Subject: Beaver Valley Power Station, Unit No. 1
Docket No. 50-334, License No. DPR-66
Main Feedwater Piping Elbow Cracking
and Misalignment (TAC 79769)

Beaver Valley Power Station, Unit No. 1
Main Feedwater Piping Elbow
Cracking and Misalignment (TAC 79769)

Updated Final Safety Analysis Report
Changes to Incorporate Regulatory Guide 1.46
Pipe Rupture Criteria

FIGURE S-2-36
FEEDWATER POINT LOCATIONS
BEAVER VALLEY POWER STATION UNIT NO. 1
UPDATED FINAL SAFETY ANALYSIS REPORT

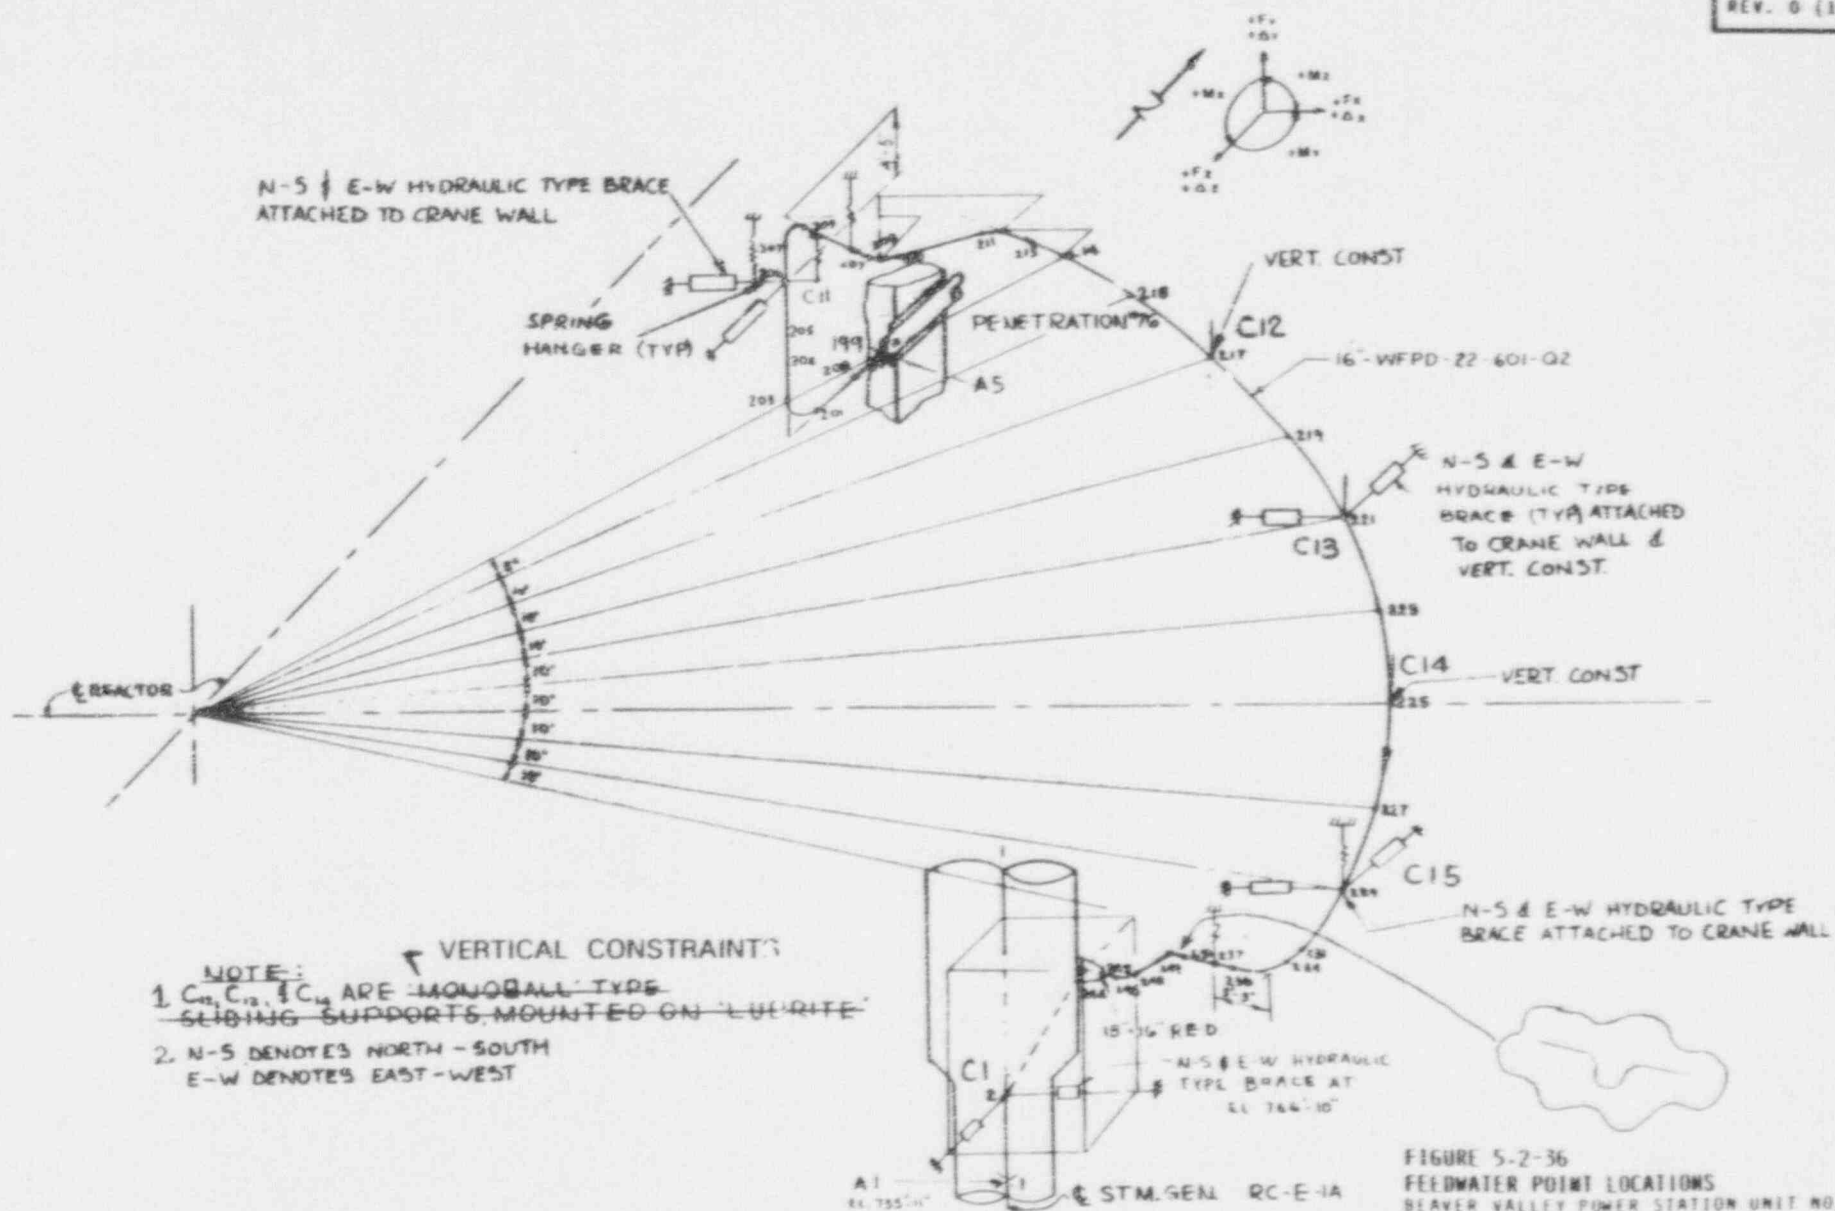
Table 5.2-16 gives the pipe break locations postulated for the three main steam and three main feedwater pipe runs inside the containment building. The loop A main steam line contains three break points and/or areas. Figures 5.2-33 through 5.2-38 coordinate the point numbers, given in Table 5.2-16 to a location along the pipe run. The restraint locations for main steam lines and for main feedwater lines are provided in Figures 5.2-39 and 5.2-40 respectively. Restraint locations are based upon what were, at the time of design fixing, the prevailing criteria for number and type of break.
